DRAINAGE SUMMARY

PROJECT: MAUNALOA HIGHWAY, REPLACEMENT OF CULVERTS BETWEEN
MAUNALOA VILLAGE AND KAUNAKAKAI - PHASE II
PROJECT NO. RS-0460(3)

STATE OF HAWAII
DEPARTMENT OF TRANSPORTATION
HIGHWAYS DIVISION

Replacement of Culverts bet. Maunaloa
Village and Kaunakakai - Phase II

Note:
For Standard Conc.
Headwall see Sht. 20

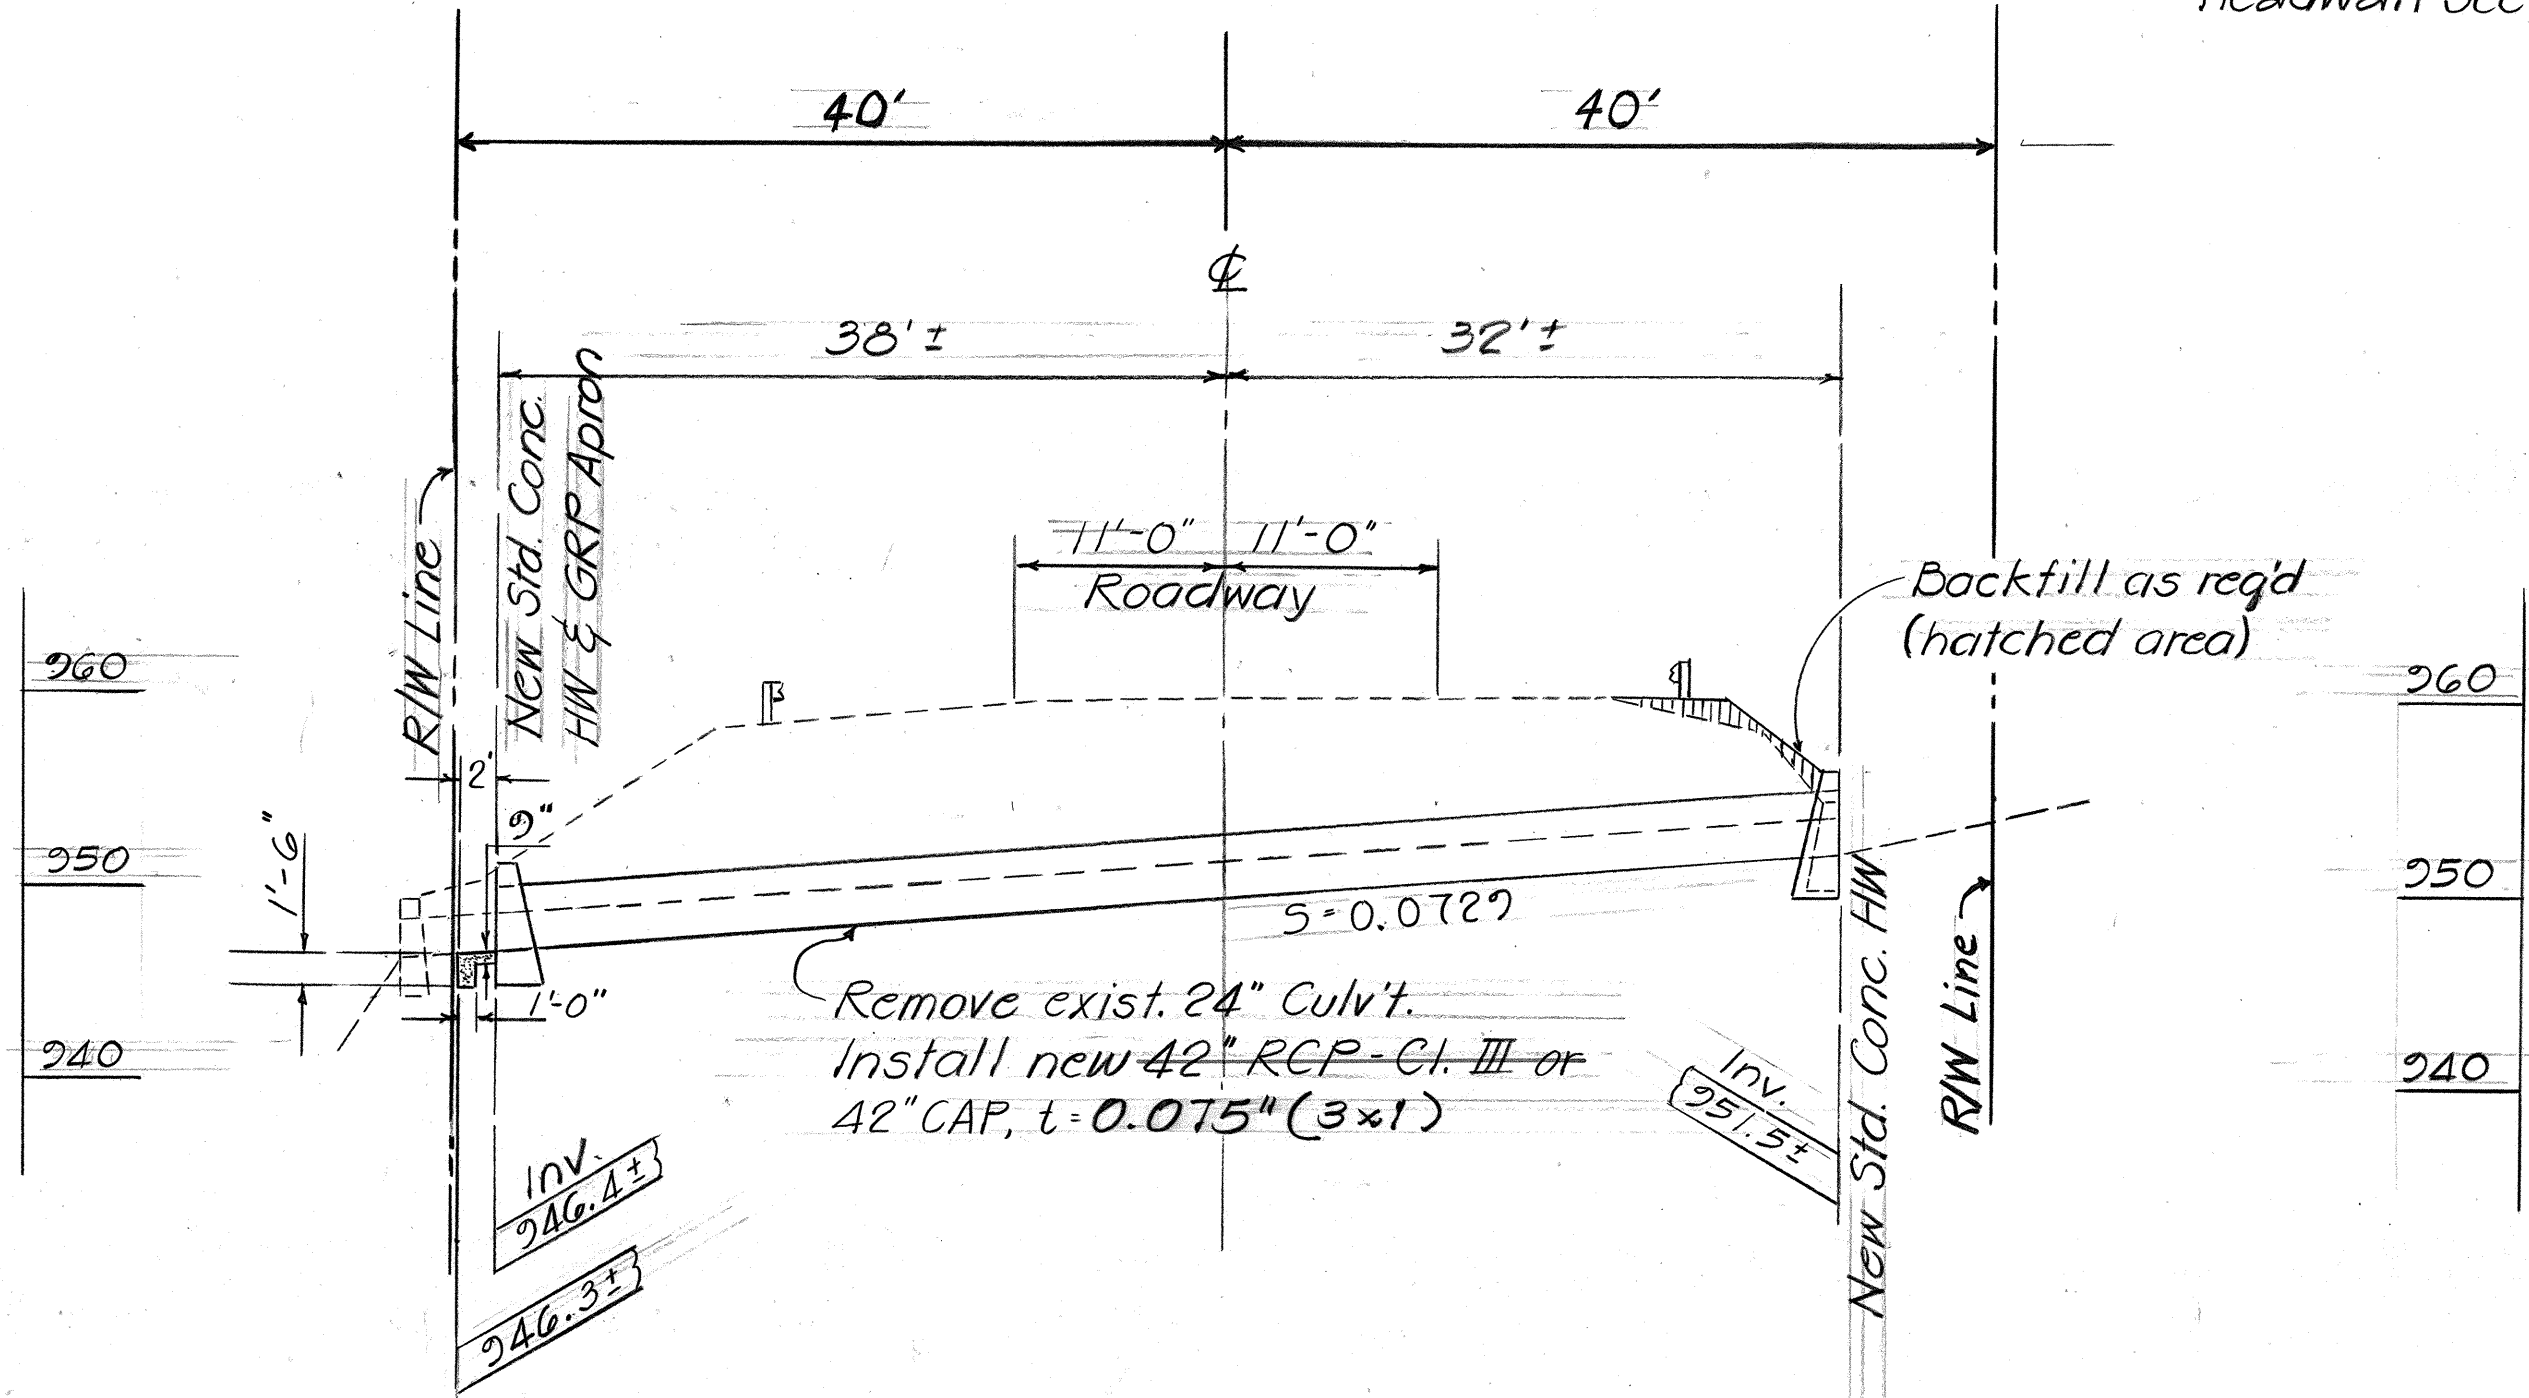
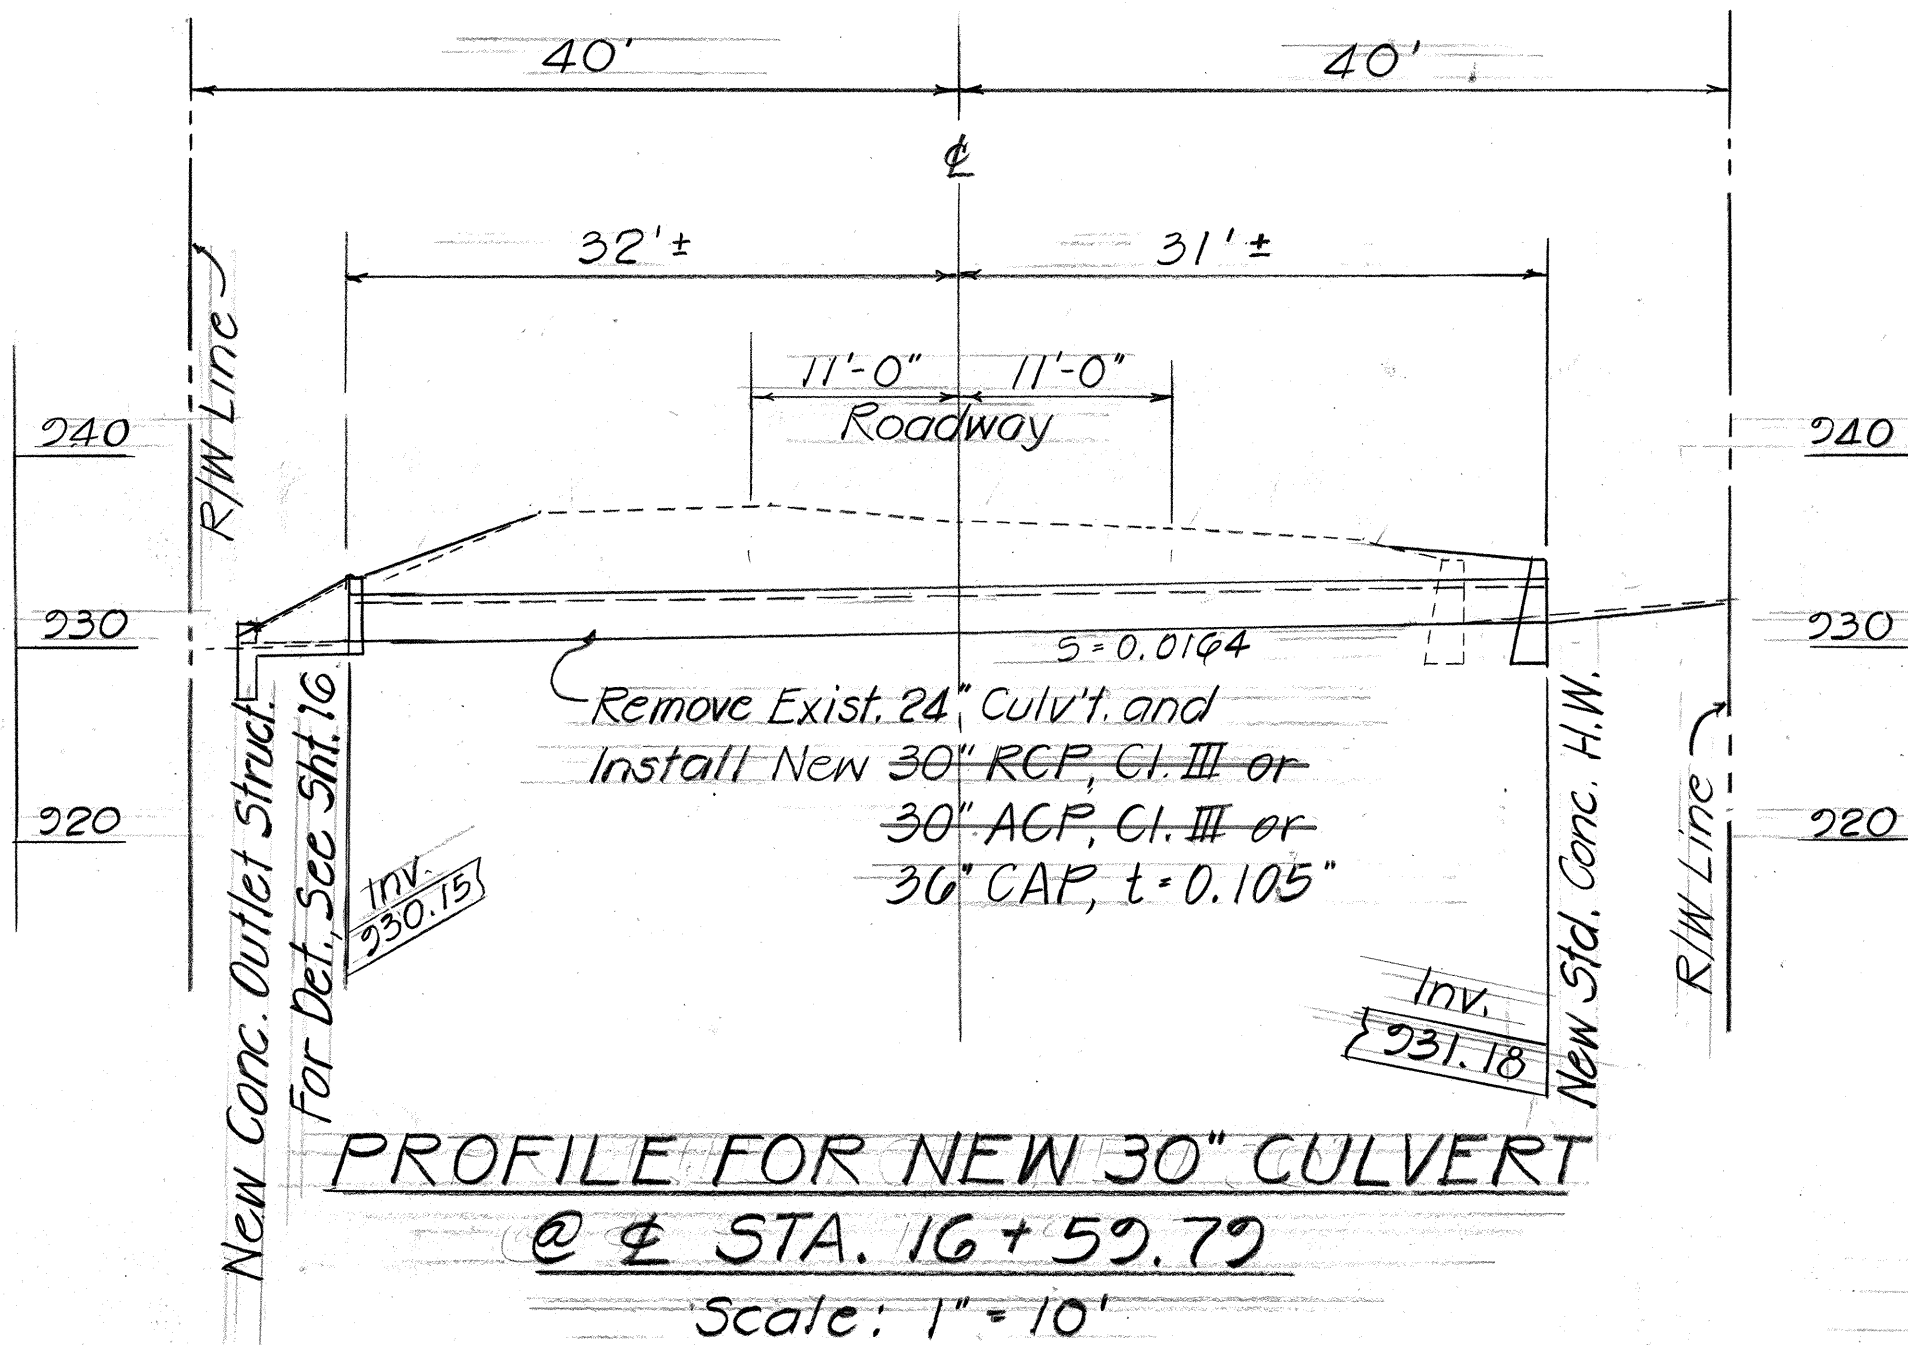
10/23/84	Per Addendum No. 1 Change 42" CAP t=0.105" to 42" CAP, t=0.075" (3x1)
DATE	REVISION
